802.3ck D2.2 Comment Resolution Clause 162, Annex 93A

Howard Heck, Intel

93A SC 93A.1.2.3

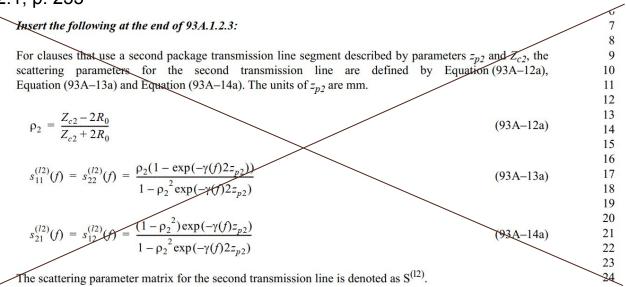
The new equations 93A-12a through 93A-14a are identical to the existing ones (without the "a") except for parameter names z_p2 and Z_c2 instead of z_p and Z_c. Having essentially duplicate equations is not a good service to the reader.

Change the paragraph after the editorial instruction to the following:

"For clauses that use a second package transmission line segment described by parameters z_p2 and Z_c2, the scattering parameters for the second transmission line are defined by Equation (93A–12), Equation (93A–13), and Equation (93A–14), with z_p2 substituting z_p and Z_c2 substituting Z_c."

Delete equations 93A-12a through 93A-14a.

PROPOSED ACCEPT IN PRINCIPLE. Resolve using the response to comment #27
